Wunder-Bar™

TECHNICAL SERVICE BULLETIN

Product: Bar-Gun Manifold

Subject: Cracking Manifold (**Potential Failure Due to Poor Manifold Frame Structural Integrity**)

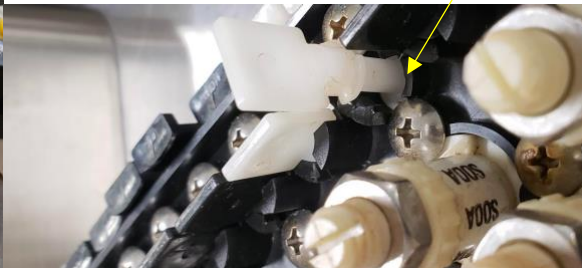
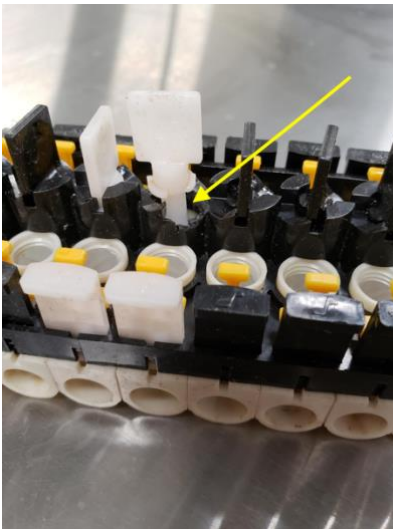
Special attention should be placed on the shut-off screw and surrounding frame region. If either of these are damaged or bent, the frame may crack and open a pressurized water or syrup line. Any sign of bending at the shut-off spade (finger hold on top of the shut-off) may be an indicator that the shut-off has been twisted beyond its normal limits and may have translated a crack to the frame.

Catastrophic blow out, typically located in the center of the manifold where higher pressures develop.

Review for Cracks and/or breaks & replace per instructions. Document manifold and contact Wunder-Bar for replacement.

Serial Numbers between – 000901759 - 000958207
